**SITE PLAN AMENDMENT  
STAFF REPORT**

**Proposed Use:** Site plan for PD-724 for Mixed-Use

**Companion Cases:** ZC-13-179/PD-724/SP-14-006

## URBAN DESIGN REVIEW, SP-15-004

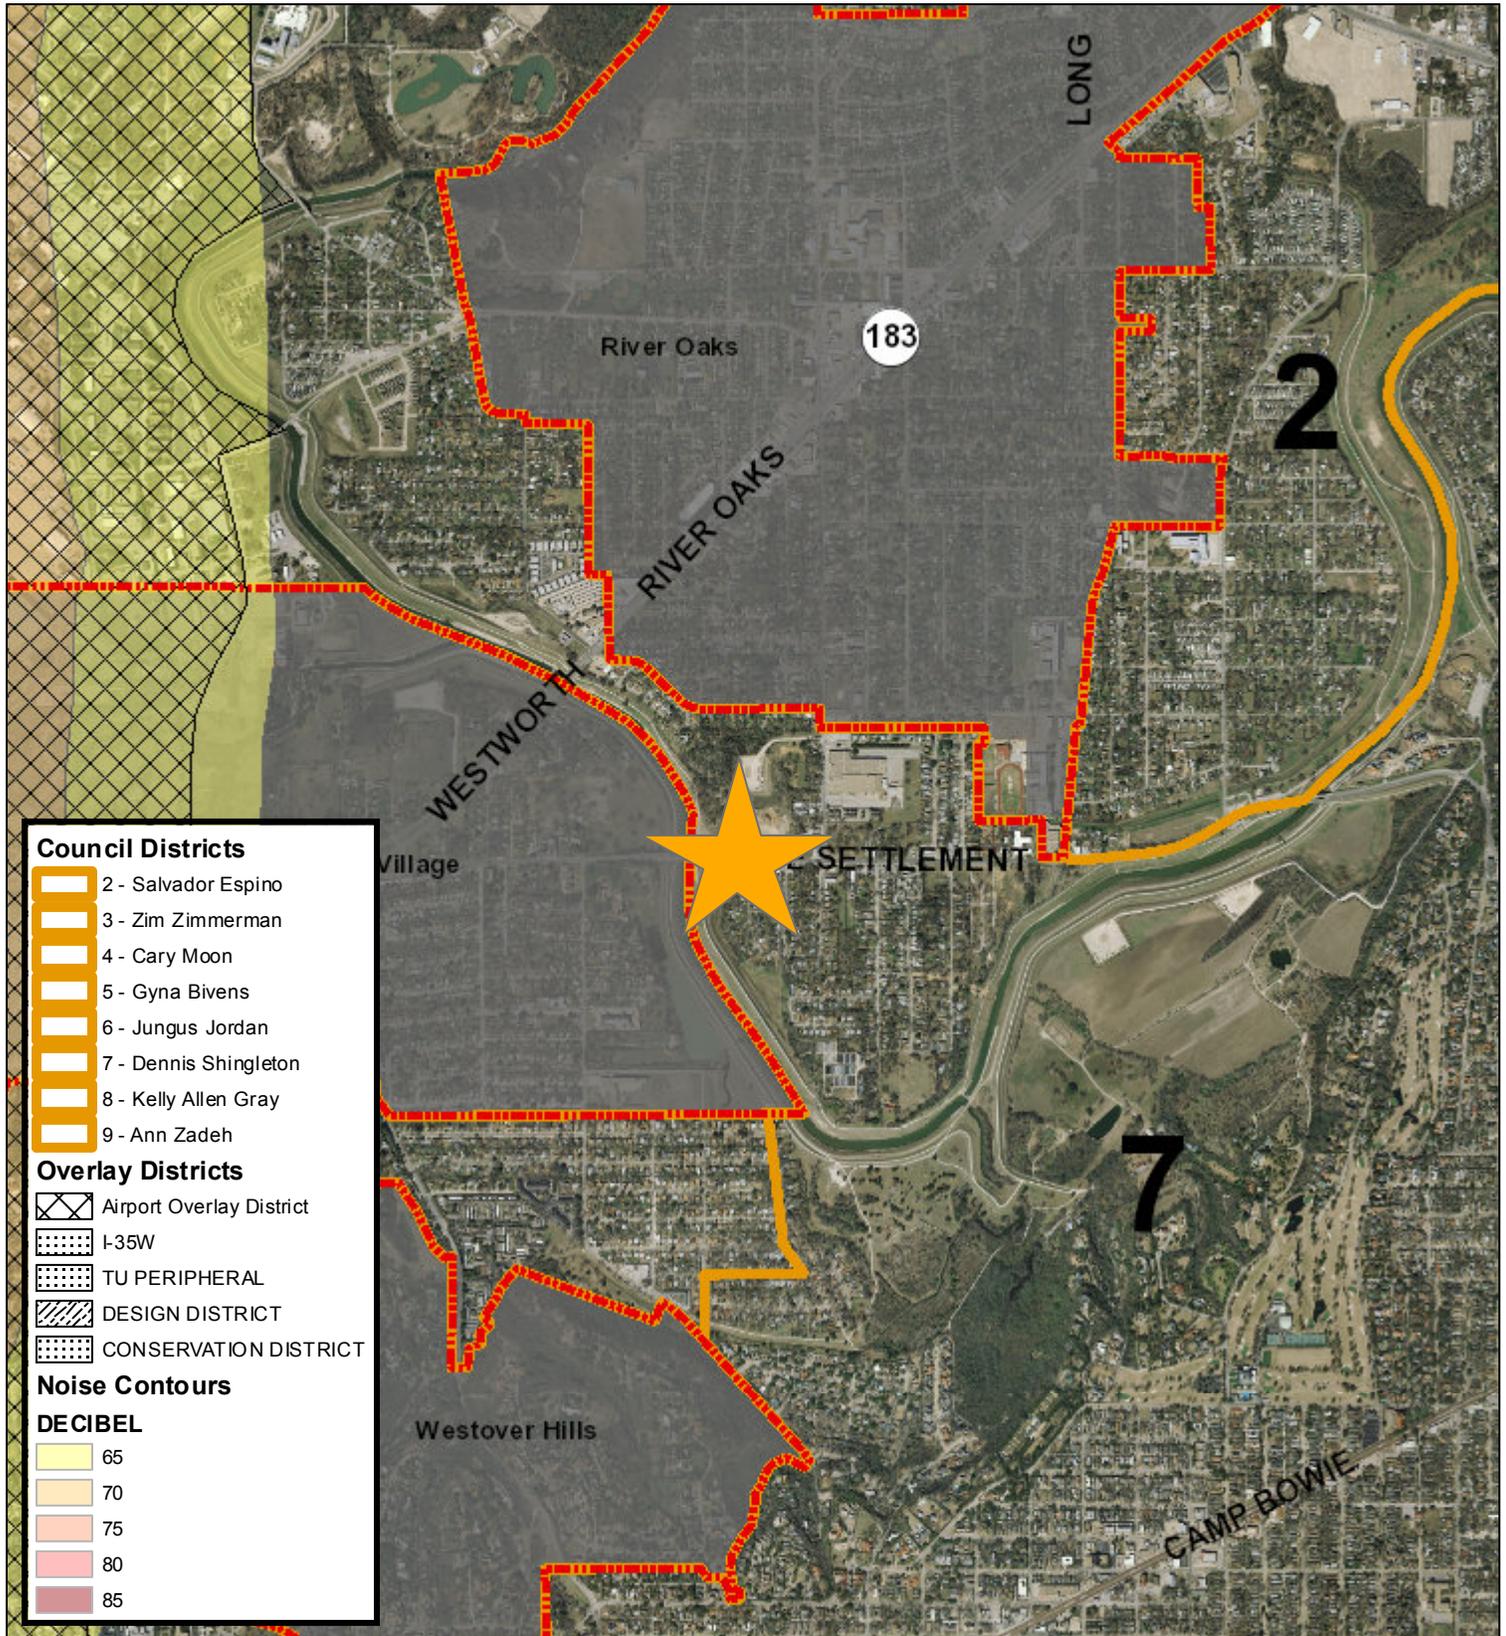
It is design staff's professional opinion that the applicant has provided an acceptable design solution that will create a walkable pedestrian environment while still accommodating the site's legitimate topography constraints. Therefore, staff recommends approval of the primary street frontage and front yard setback waiver.

It is design staff's professional opinion that the waiver to provide more than the maximum number of parking spaces be denied. Due to the proximity of the Trinity Trails, design staff recommends the project utilize this unique asset to promote the use of cycling and walking and use extra land not devoted for surface parking as an open space amenity for the multi-family residents until the land is needed for future development phases of the project.

Design staff recommends that the waiver to allow detached garages to be located between the building front and the street be granted but with the assurance that the street/driveways be built to minimize curb cuts and vehicular conflicts, the garages be built with transparency, enhanced street facing pedestrian entrances into the multi-family complex are provided, and that the garages be built in a manner that allows them to transition to retail use over time.

**SITE PLAN - PHASE I AND II**

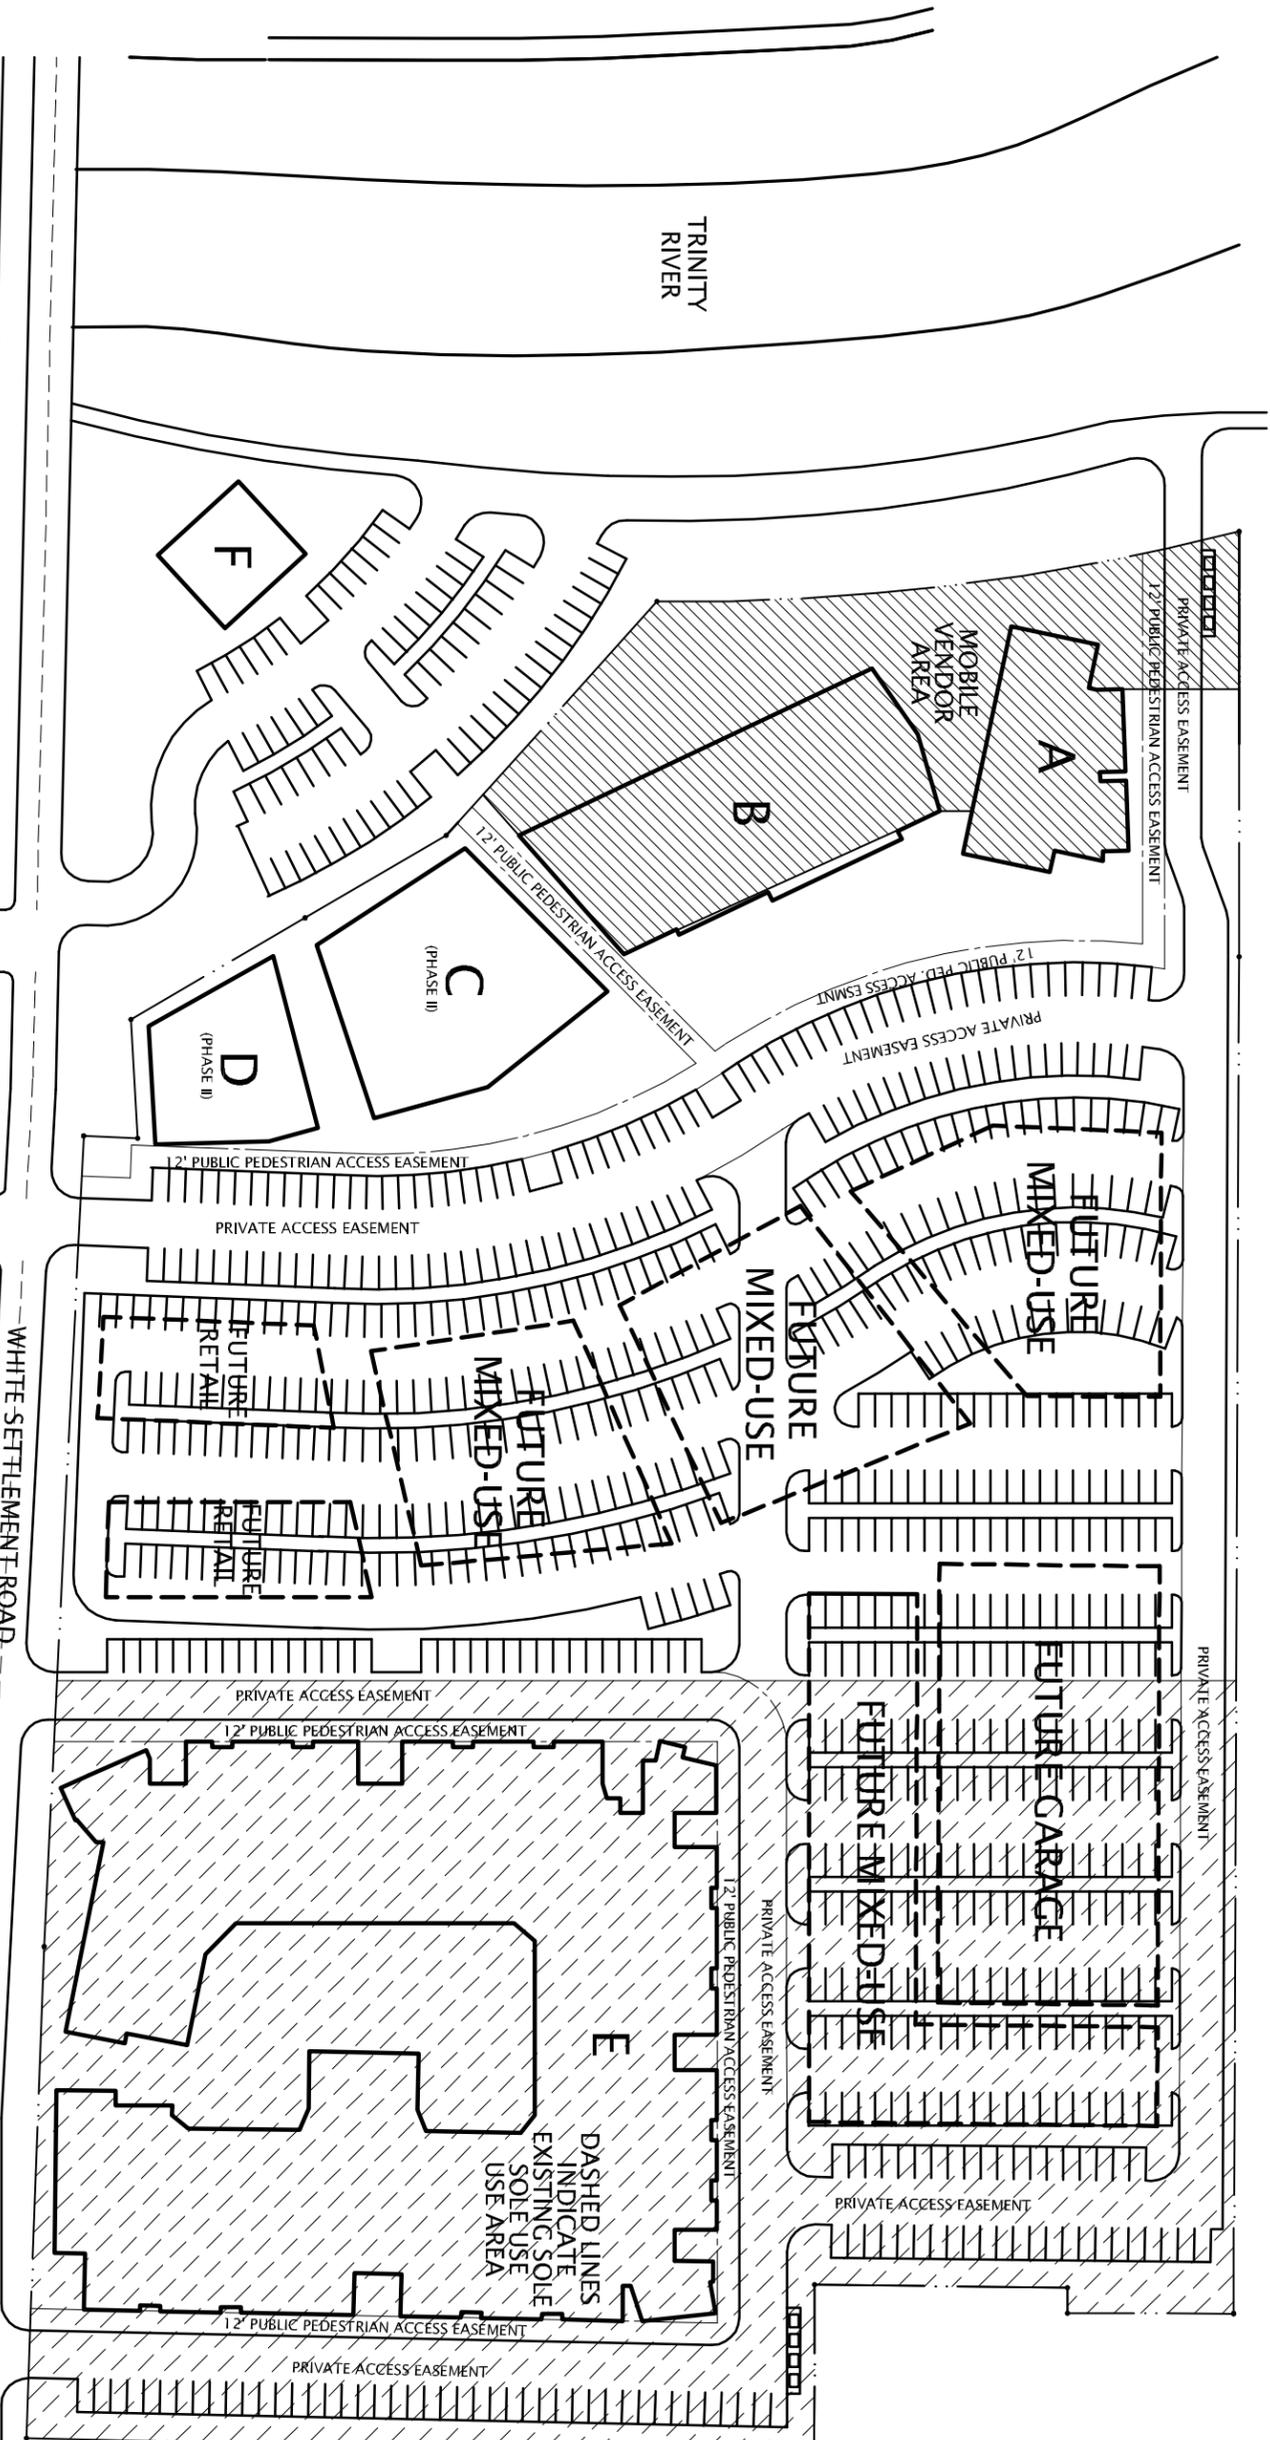
1. Indicate whether streets are public or private with dimensions.
2. Indicate the dimensions of drive approaches and easements.

1. Proposed 35' setback from the primary street due to significant topography constraint, (buildings A, B and C). *(waiver requested)*
2. 0% primary street frontage (buildings A, B and C). *(waiver requested)*

3. Vehicular drive-through lane located between the building front and the street. *(waiver requested)*
4. ~~Proposed to provide more than 100% maximum parking with large surface parking lots. *(waiver requested)*~~
5. Proposed to have street-facing, detached garages lining the north, east and west facades of the multifamily block (building E on the site plan). Design staff recommends the waiver to allow detached garages to be located between the building front and the street be granted with the following conditions:
  - A. Streets/driveways be built to minimize curb cuts and vehicular conflicts.
  - B. Garages be built with transparency.
  - C. Provide enhanced street facing pedestrian entrances into the multifamily complex.
  - D. Garages be built in a manner that allows them to transition to retail use over time. *(waiver requested)*

*Buildings A, B, and C exceed the maximum 20 foot setback on the primary street. On buildings A, B, and C 50% primary street frontage is required, the applicant is proposing 0%.*

*Chapter 6 of the zoning code allows commercial uses up to 125% parking when extra trees are provided. The mixed-use ordinance caps your parking at 100% of the Chapter 6 requirement in order to reduce the amount of surface parking lots and to encourage other forms of mobility rather than driving. The Chrystal Springs project is providing more than 100% maximum parking with large surface parking lots.*

*The mixed-use ordinance does not allow parking between the building front and the street unless it functions as on-street parking. The Crystal Springs project is proposed to have street-facing, detached garages lining the north, east and west facades of the multi-family block (Building E on the site plan). These garages function as off-street parking and thus are not allowed under the ordinance.*

It is design staff's professional opinion that the applicant has provided an acceptable design solution that will create a walkable pedestrian environment while still accommodating the site's legitimate topography constraints. Therefore, **staff recommends approval of the primary street frontage and front yard setback waiver.**

**It is design staff's professional opinion that the waiver to provide more than the maximum number of parking spaces be denied.** Due to the proximity of the Trinity Trails, design **staff recommends the project utilize this unique asset to promote the use of cycling and walking and use extra land not devoted for surface parking as an open space amenity for the multi-family residents until the land is needed for future development phases of the project.**

**Design staff recommends that the waiver to allow detached garages to be located between the building front and the street be granted but with the following conditions:**

- 1) Streets/driveways be built to minimize curb cuts and vehicular conflicts**
- 2) Garages be built with transparency,**
- 3) Provide enhanced street facing pedestrian entrances into the multi-family complex**
- 4) Garages be built in a manner that allows them to transition to retail use over time.**
